Audacy Corp.
340 S. Lemon Ave., Suite 8787
Walnut, CA 91789
<http://audacy.space>
info@audacy.space

**Re: Audacy Corporation, Minor Amendment to IBFS File No. SAT-LOA-20161115-00117
(Call Sign S2982)**

Relay → Base User (Transmit) Beams & Channels (BT--)

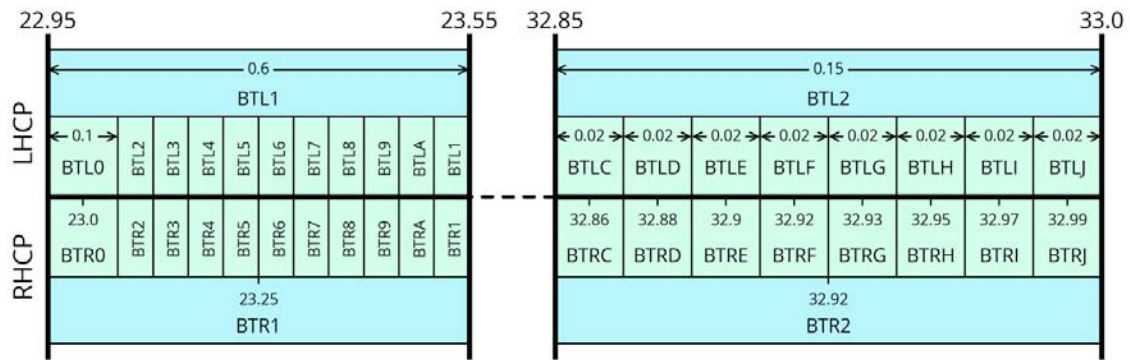
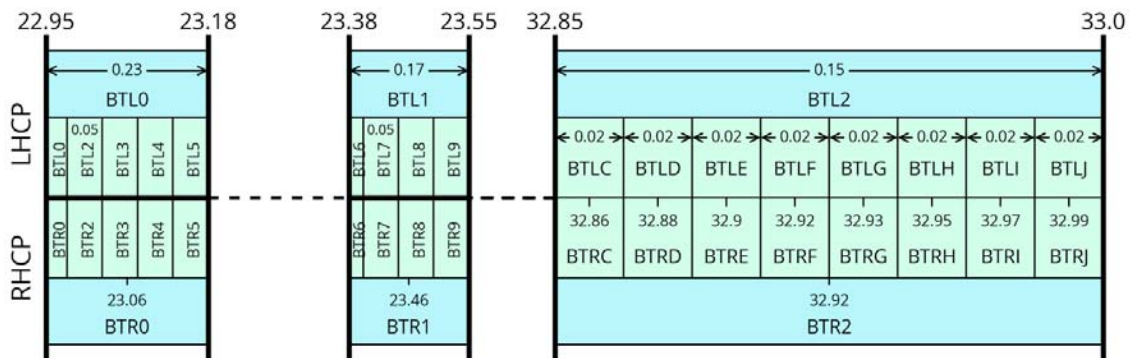
of the 23.18 - 23.38 GHz band in the Relay Satellite ↔ Base User Satellite beams and channels, both identified as BR-- and BT-- in Audacy's Schedule S. The affected sections of Audacy's Application are: Narrative Tables 1 and 2, Figures III-7 and III-8; and Schedule S *Operating Frequency Bands, Receiving Beams, Receiving Channels, Transmitting Beams, and Transmitting Channels*.

Original Frequency Plan (Figure III-7 in the Audacy Narrative Exhibit, p.25):

Updated Frequency Plan:

Base User → Relay (Receive) Beams & Channels (BR--)

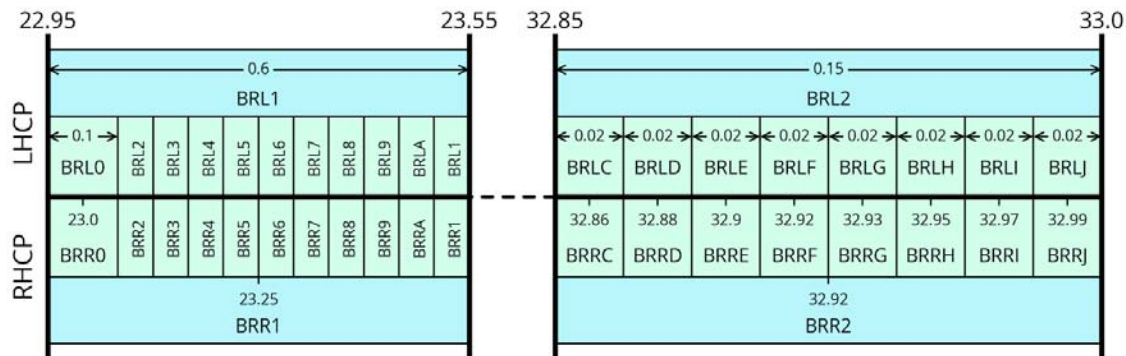
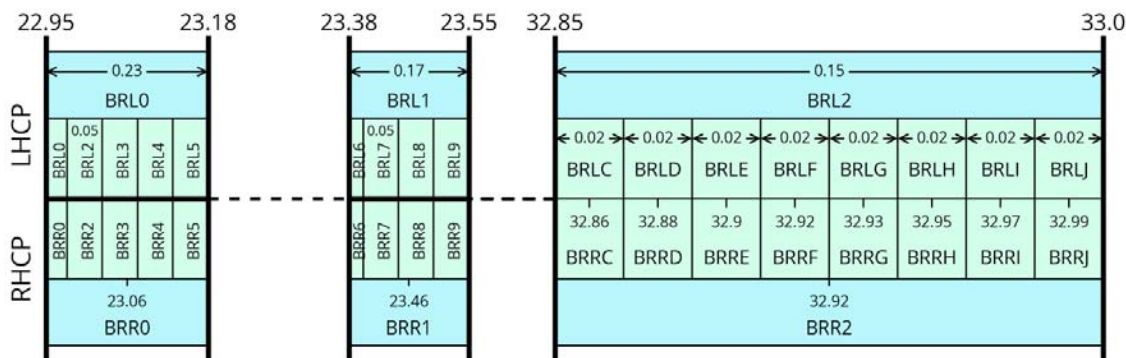
Original Frequency Plan (Figure III-8 in the Audacy Narrative Exhibit, p. 26):

Updated Frequency Plan:
